APPENDIX E.12  
Surveillance Network Program (SNP)  
Modification Application

**Re: Mary River Project – Changes to Surveillance Network Program (SNP) and Alignment of Schedule I of the Type ‘A’ Water Licence 2AM-MRY2540**

**FIGURE E12.1**

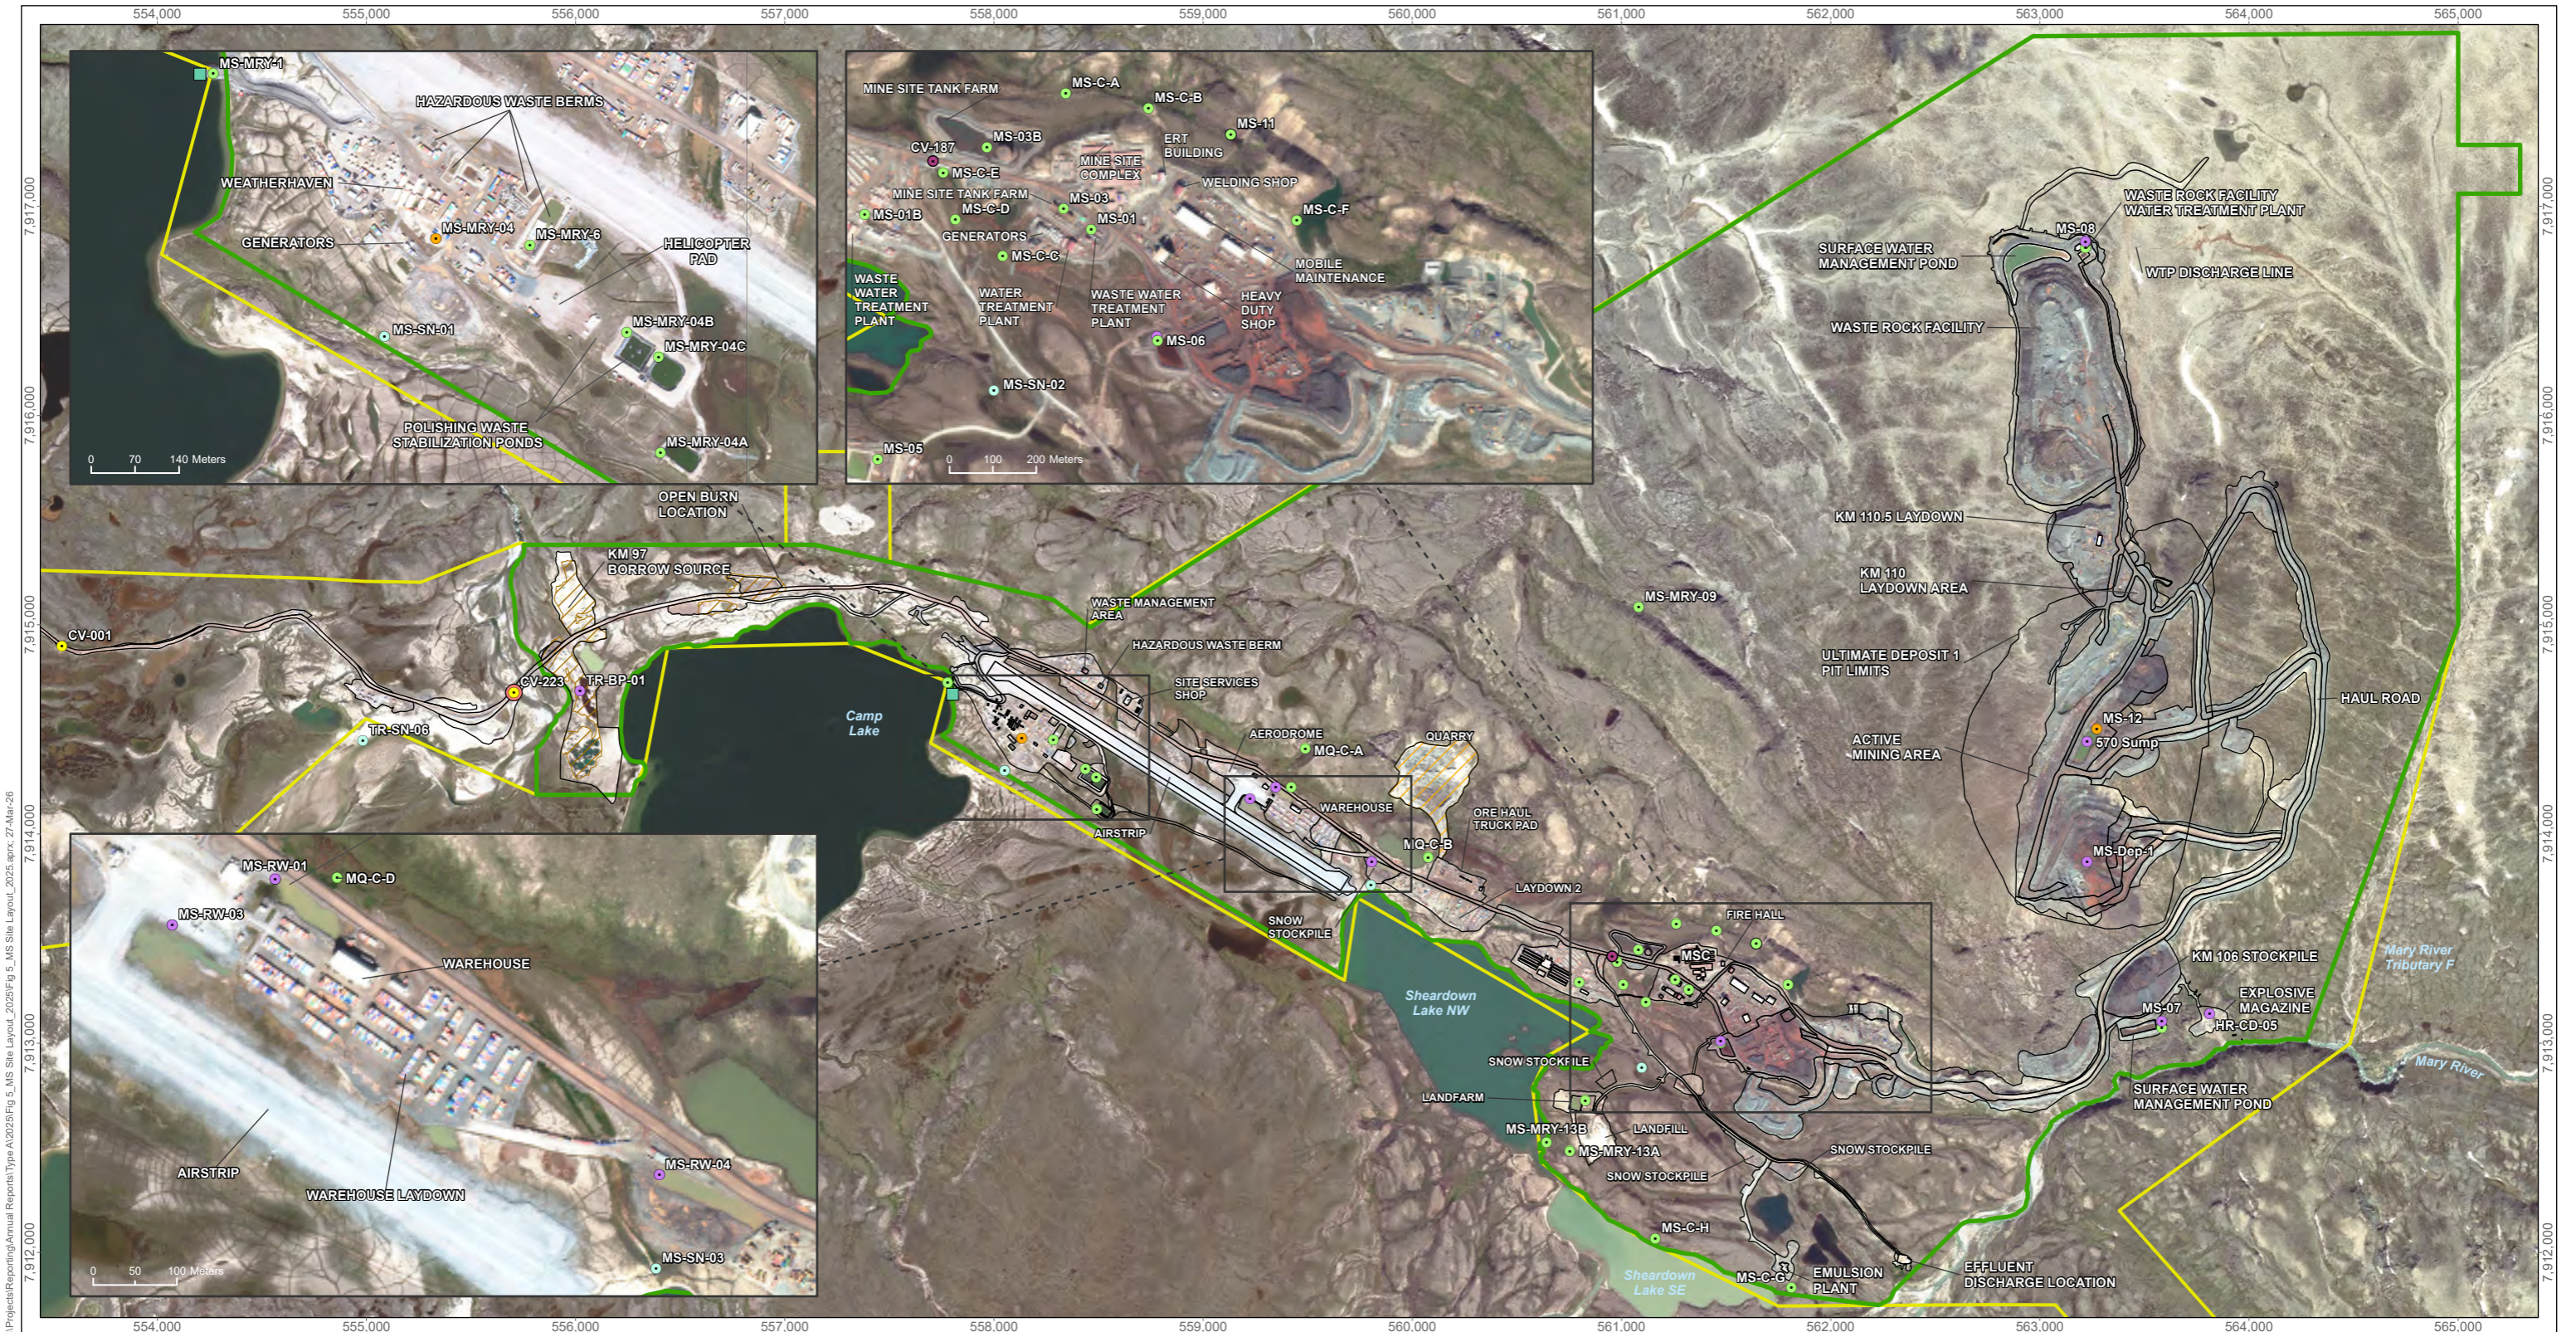
Baffinland is proposing to add one SNP station denoted MS-12 at the 570 Sump that will be constructed within the ultimate pit boundary at Deposit No. 1.

Baffinland notes that a monitoring station with the identifier MS-12 was previously submitted with Modification 13, however the associated settling pond was not constructed due to permafrost considerations, and therefore we request the re-assignment of this station identifier to the 570 Sump effluent discharge.

Station ID	Station Description	Current Location (NAD83, Zone 17W)		Proposed Change	Reason for Change
		Easting	Northing		
MS-12	Mining Area 570 Sump	-	-	New station to be located at: N71° 19' 25.04" W79° 19' 46.82"	Water will be captured in the 570 Sump and will be discharged towards Mary River when effluent discharge criteria are met, rather than pumping water to the Waste Rock Stockpile Pond

Station	Description	Phases	Monitoring Parameters	Frequency
MS-12	Mining Area 570 Sump	Operations	Groups 1 and 7	Once prior to discharge and monthly hereafter
			Group 3	Annually
